TO: Pinehurst Historic Preservation Commission
FROM: Alexandria Rye, Senior Planner
DATE: 8/19/2021
SUBJECT: Minor Work COA's Issued

**HISTORIC PRESERVATION COMMISSION
REGULAR MEETING
JULY 22, 2021
ASSEMBLY HALL
395 MAGNOLIA ROAD
PINEHURST, NORTH CAROLINA
4:00 PM**

To: Historic Preservation Commission
From: Alexandria Rye, Senior Planner
CC: Alex Cameron, Planning Supervisor
Shannon Konstantinou, Administrative Specialist
Date: August 16, 2021
Subject: Major COA Request for 44 McKenzie Road E

Proposed Enclosure Exterior and Metal Roof

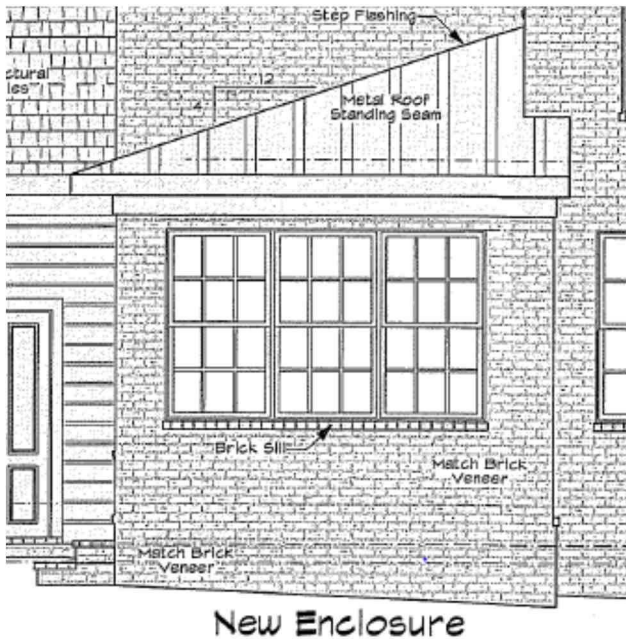
1. Replace all vinyl windows with Pella Aluminum Clad windows
2. Add addition of sitting room off the master bedroom, exterior to match existing
3. Add overhead door for golf storage
4. Enclose existing screen porch with Pella windows
5. Exterior Modification
 - a. One enclosure (rear) to have standing seam metal roof (color not provided)
 - b. Sunroom addition/patio enclosure proposed to have French doors
 - c. Enclosed patio proposed to have brick exterior painted gray
 - d. Elevation color change from white to gray painted brick
 - e. Change shutters from white vinyl to black mahogany

tree #1

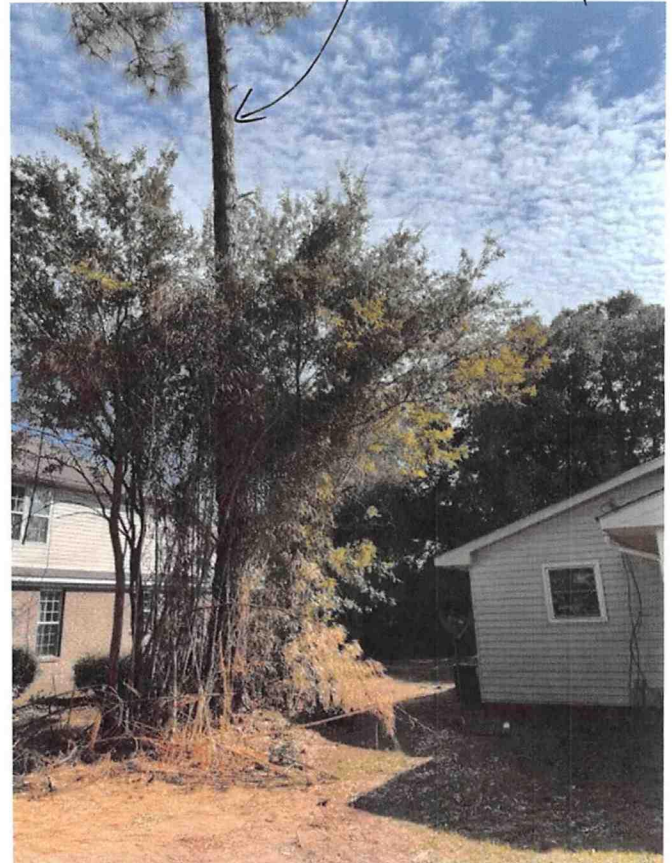
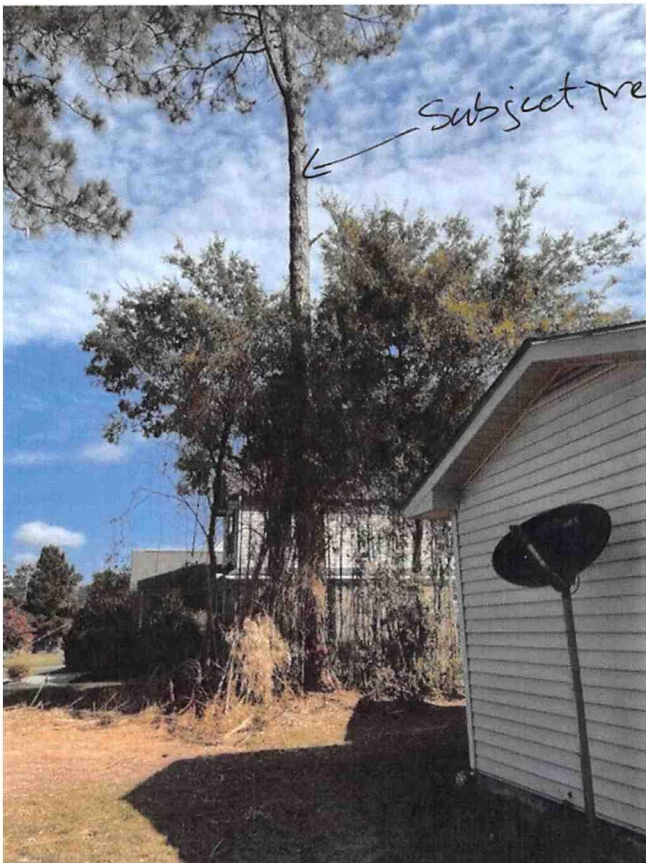
1. Adjacent property owners have been noticed and the property was posted.
2. The applicant has submitted an application, photos of the existing home and renderings of the proposed work.
3. The applicant is seeking to remove existing healthy trees greater than 12" diameter at breast height.

Applicant seeking to remove two trees from property. These proposed changes are requested at 85 McIntyre Road. The property can be further identified in the Moore County Tax Registry by Moore County PIN Number 856205087736. According to recent records on file with the Moore County Register of Deeds, the applicant purchased the property last month.

Proposed door to replace garage door

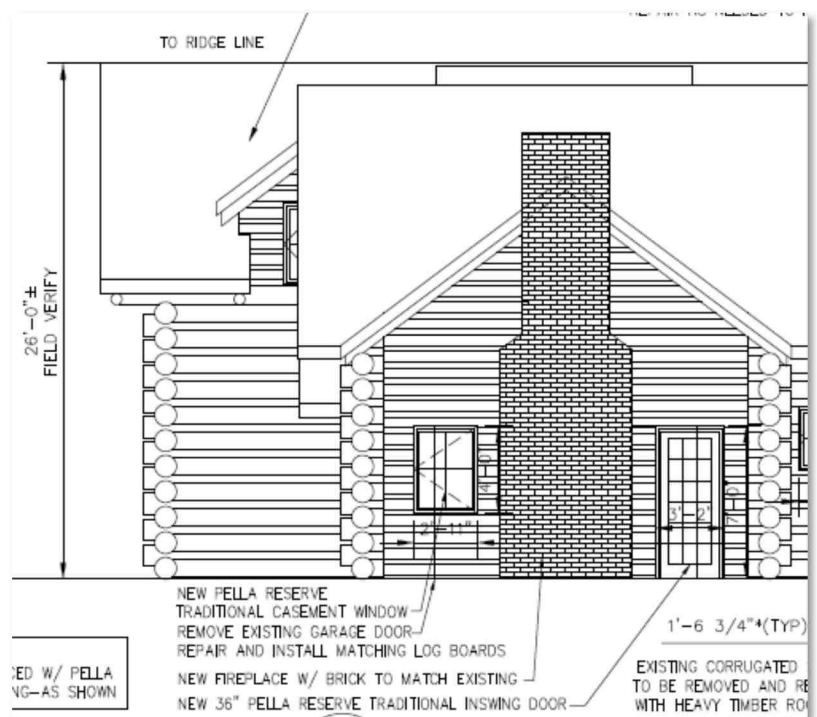
Applicant is proposing exterior renovations, primarily the change of a prior design which was a fireplace plan for guest house where the existing garage door is located, now being proposing with ingress/egress doors. The property can be further identified in the Moore County Tax Registry by Moore County PIN Number # 855212951773.

This request is considered to be Major Work due to the change of plans from previous plans and the extent of the structural changes and requires consideration of a COA by the Historic Preservation Commission (HPC).

The applicant has submitted a complete application and provided additional documentation in an attempt to satisfy the burden of proof. The proposed change from garage door to entry appears to be compatible and of the same style and material of the structure. Given the details of what has been submitted for review, the proposal appears to be compatible with other buildings within the Historic District. If the Commission were to consider approval of this request, staff would recommend the 1st motion:

Site Plan for Proposed Plaza

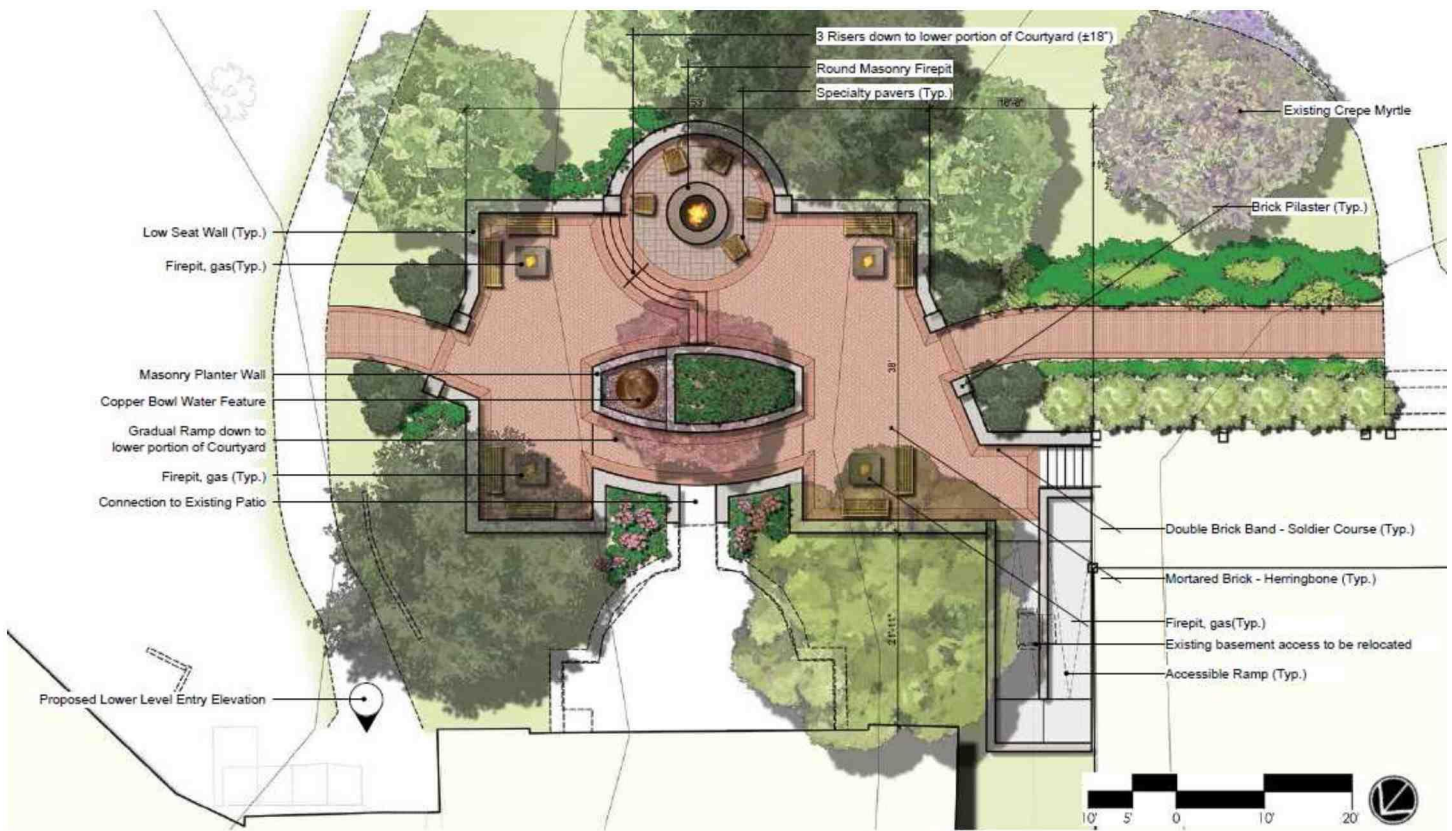
Applicant is seeking to make exterior modifications including material and window changes, expanding the porch of the Hotel Lobby and Veranda, and the addition of Ryder Cup Lounge Plaza. The property can be further identified in the Moore County Tax Registry by Moore County PIN Number # 855212865690. Note that this staff report includes the review of two separate applications submitted by the Resort as there are two separate projects. The public hearing was noticed in accordance with the Pinehurst Development Ordinance (PDO) and NCGS 160D-406.

Staff recommends the above motion because the proposed location, improvements, and material proposed for the renovations may not be consistent with all the Historic Guidelines but appear to be congruous with the existing structure and district. Even though the addition will be on a principal elevation near the entry, all the design elements include architectural details found on the existing structure including the windows, arches, columns and awning. The addition of the outdoor brick plaza will replace an existing lawn area but, as indicated on the submitted material, will be heavily landscaped and only accounts for an increase in approximately 3,000 square feet of coverage. Brick walls are listed as an appropriate fence/wall type in the guidelines.
